Addendum Hearing Report for Proposed Private Plan Change 93: Warkworth South to the Auckland Unitary Plan (Operative in part)

Section 42A Hearing Report under the Resource Management Act 1991

Report to:	Hearing Commissioners
Hearing Date/s:	4 to 8 November 2024
File No:	Hearing Report – Proposed Private Plan Change 93 (PC93)
Report Author	David Wren, Consultant Planner
Report Approvers	Peter Vari, Team Leader Planning Regional, North, West and Islands
Report produced	16 October 2024

XXX.9.2 Morrison Orchard: Shelterbelt Plans

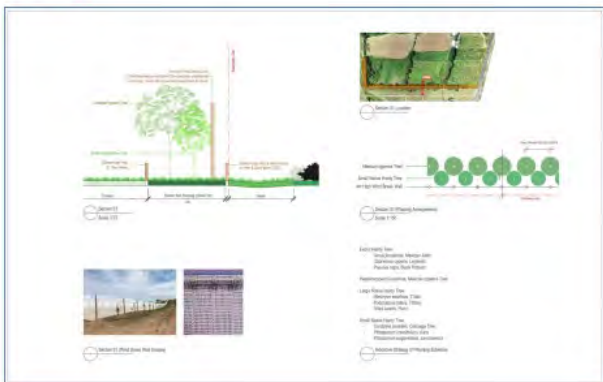
- 3.9 In response to the landscape concerns, the applicant has introduced a new standard ‘IXXX6.13 Shelterbelt Landscape Protection (Orchard Road Boundaries)’, as well as additional matters of discretion and assessment criteria (replicated below). The additional standard is quite prescriptive with regards to how the replacement of trees is to occur. This includes plant arrangement / set out and species and use of a 4m high wind break wall (mesh fence). It will be important that the removal of the mesh fence is enforced, as while not uncommon in productive landscapes such as vineyards, a height of 4m for the entire boundary length could have adverse visual amenity effects.

3.11 While the introduction of the shelter belt protection and / or reimplementation has been introduced, I retain my view that collectively all the proposed permitted uses / activities within the Morrisons Heritage Orchard Precinct could weaken the values of the site and not achieve the heritage rural character which is said to be retained. I support the recommendation within Councils S42A Report which proposed to change the permitted activity status of Table XXXX.X.1

- (1) The existing shelterbelts shown on the General Arrangement Plan in Rule XXX.9.2 below shall be permanently retained and maintained, including the replacement of trees when necessary, in general accordance with the relevant Section 1 and 2 plans.

~~1593.9.7 Tree Management Plan~~

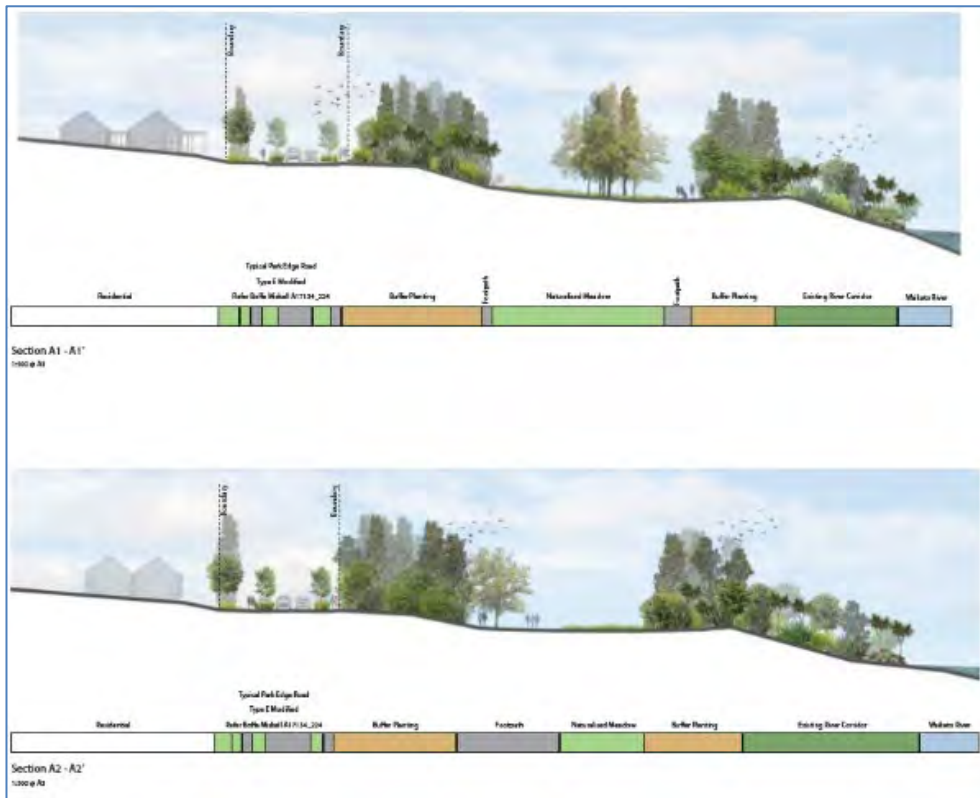
The following precinct provision is unnecessary as the AUP(OP) provides for adequate consideration of vegetation alteration and/or removal in SEAs, riparian areas etc. through E15, E16 and E26. Removal of covenanted habitat is a Discretionary Activity under existing covenant obligations. Furthermore the assessment is only limited to trees, not sub-canopy, shrubs, groundcover or herbaceous layers, and has no regard to fauna. I suggest the following deletion.
